# **FEC\_Overhead considerations**

**Eric Lynskey**  
**IEEE 802.3av Interim Meeting April 13-14, 2008**  
**Tokyo, Japan**

# Current situation in D1.1

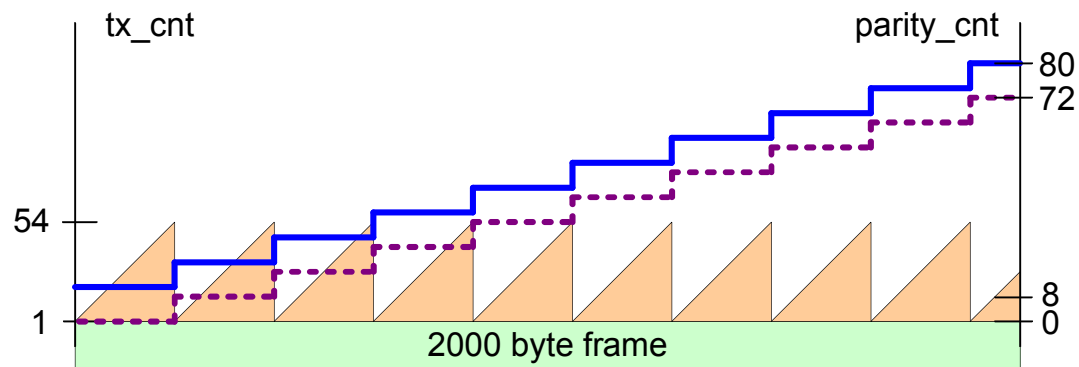
- FEC\_Overhead equation
  - It does not properly account for overhead (bad).
  - Count in units of time\_quanta (inefficient).
  - Choice needs to be made between trading off bandwidth and timestamp jitter.
- Determination if last frame fits in burst
  - MPCP has no knowledge of delay MAC may add.
  - Need to know if last frame will fit in burst.
  - Possibility of frame extending beyond grant slot.
  - Equations performing this check need to be fixed.

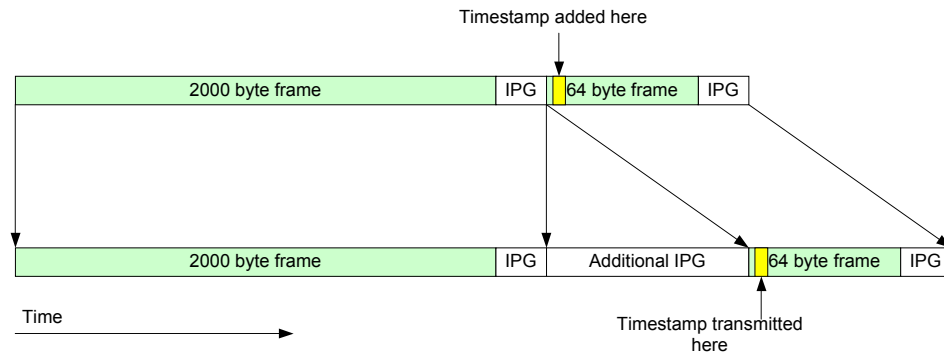
- If the delay is too little, new frame will have timestamp inserted and will be delayed in the MAC while the RS continues to defer the MAC.

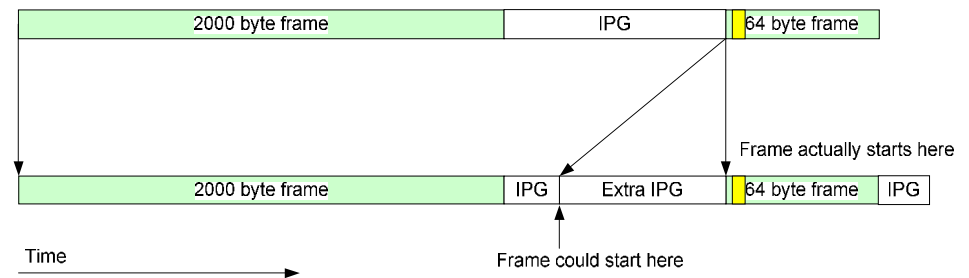
- If the delay is too much, there will be wasted bandwidth as MPCP delays a new frame even though the MAC is capable of transmitting one.

# Proposal for Comment XXX

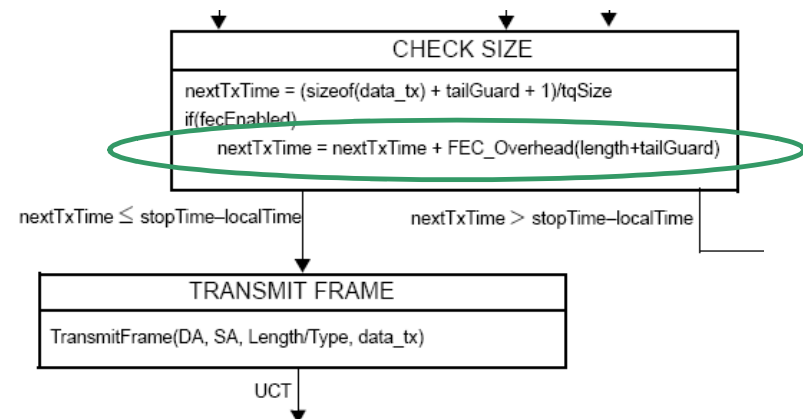
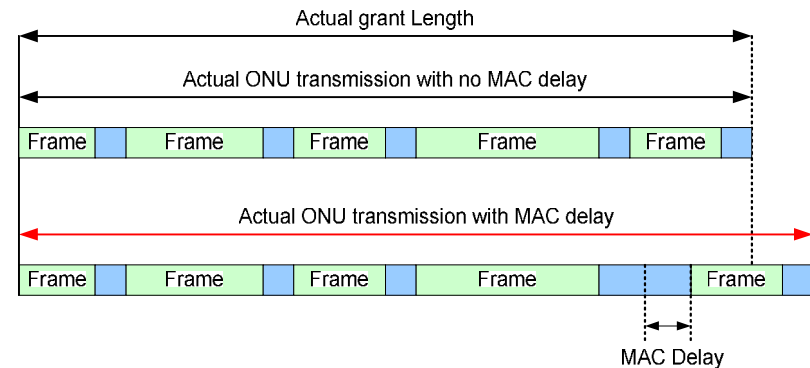
- Option 1 is the best solution.
- FEC\_Overhead equation for 10G-EPON becomes:

$$FEC\_Overhead = \left\lceil \left\lfloor \frac{Length}{216} \right\rfloor \times \frac{32}{20} \right\rceil$$

Length = Frame Length + Preamble + Minimum IPG
